TfNSW reference: REN25/00075/002

Your reference: SSD-48225958

**SSD-48225958 – Gundry Solar Farm – Response to Submissions - Goulburn Council**

Corner of Braidwood and Sloane

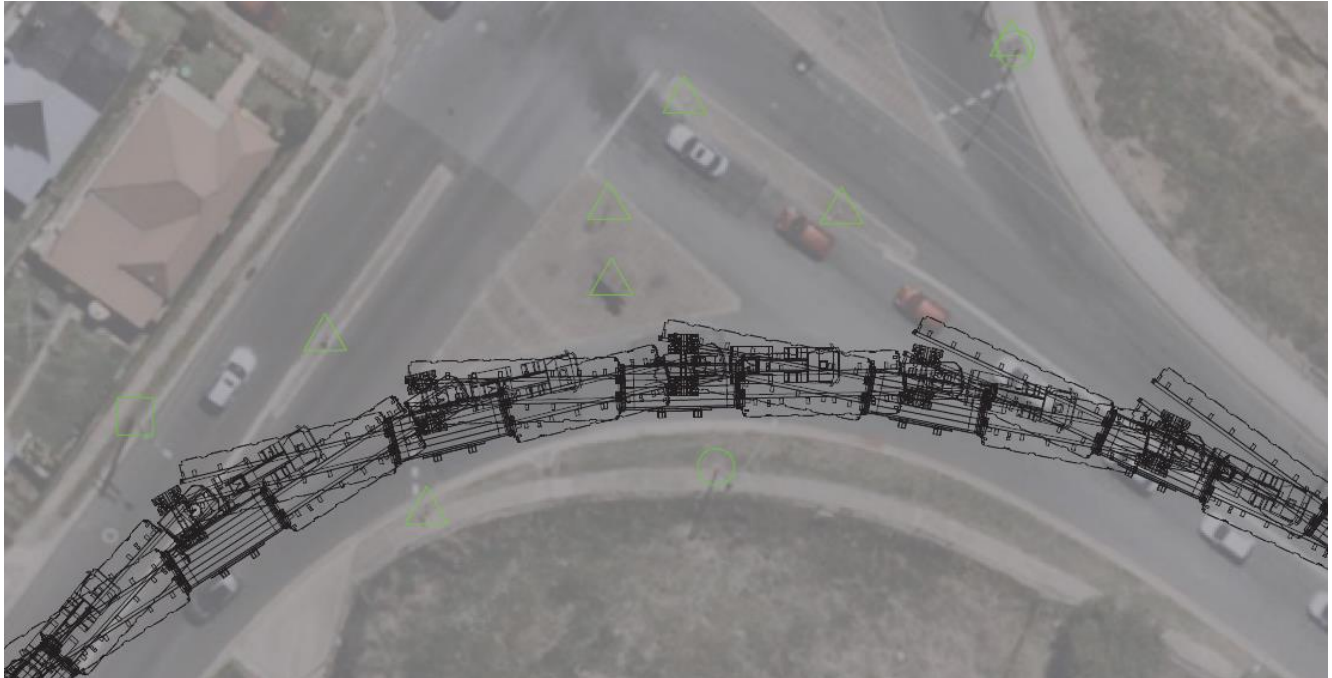
f) Show the project traffic added to each intersection that has been analysed in the TIA.	<p>same time as the Gundry construction project data. Proponent is to consider offsetting start times as a mitigation measure to reducing impacts to the urban roads around Goulburn</p> <p>f- OPEN – Proponent is to confirm and clearly label the raw traffic data for the intersection of Bungonia / Braidwood and Braidwood / Sloane Street that has been used in the intersection analysis.</p>

3.	<p>The origin, destination and routes are to be shown for:</p> <p>a) Employee and contractor light traffic.                  b) Shuttle buses.                  c) Heavy vehicle traffic.                  d) OSOM vehicle traffic.                  e) OSOM high risk loads.</p>	<p>PARTIALLY ADDRESSED – <b><u>Pending electronic SIDRA files being provided:</u></b> TfNSW notes that turning volumes and routes for light vehicles/heavy vehicles/shuttle buses should be focused to reduce the impact on the state road network, particularly on the intersections of Braidwood / Sloane Street and along Braidwood Road.</p>

Median at Botany Road / Bumborah Point Road

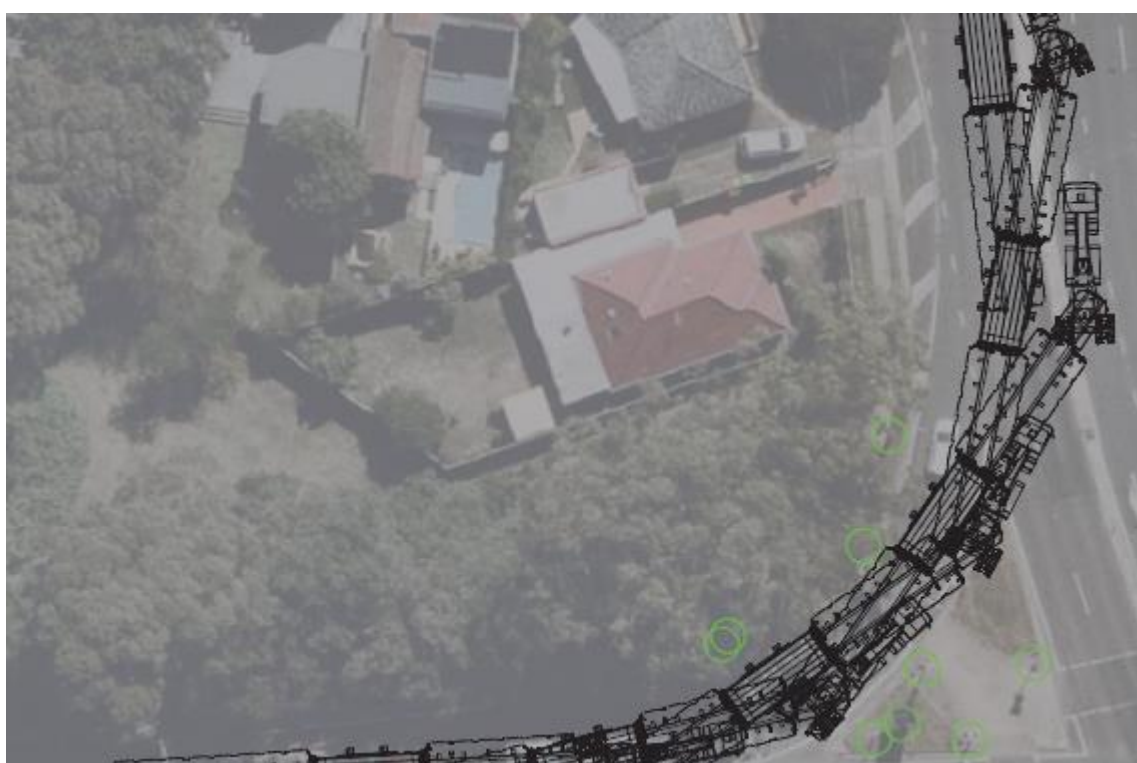
<p>i) Traffic mitigation measures or road works, modifications, or road upgrades to facilitate the movement of the high risk OSOM(s) on the state road network around, though, under or over any at-risk road structure that has been identified from the review and assessment of the above point (h).</p>	<p>Once complete, the proponent is to revise their routes to ensure they have accounted for updated assessment and completed bridge assessments.</p> <p>i – OPEN – The provided swept paths demonstrate the following road structures will be impacted:</p> <p><u>Botany Route</u></p> <p>Median on Botany road being crossed to make turn into Bumborah Point Rd</p> <p>Median at the corner of Bunnerong Rd and Botany Rd/ on Bunnerong Road</p> <p>Median on Kent Road being crossed to make turn.</p> <p>Median at Corner of Braidwood and Bungonia</p> <p><u>Kembla Route</u></p> <p>Median and Corner of M1 and Picton Road</p> <p>Median at Corner of Braidwood and Sloane</p> <p>Median at Corner of Braidwood and Bungonia</p> <p>TfNSW will not support high-risk OSOM traversing state road infrastructure (medians, roundabouts, traffic islands etc) due to the risk of damage to this infrastructure.</p> <p>The revised TIA is to provide alternative swept paths with differing vehicle configuration or strategic concept designs that identify the scope of roadworks, pavement strengthening, or modifications to the state road infrastructure (e.g., roundabouts, medians, traffic islands, pedestrian refuges) for locations where high-risk OSOM swept paths indicate high-risk OSOM traversing the state road infrastructure.</p> <p>Note: Examples of road upgrades and modifications to this type of infrastructure include pavement strengthening (asphalt), removal or partial removal of the infrastructure, and removal and replacement with a suitable alternative that complies with Austroads and TfNSW requirements.</p>
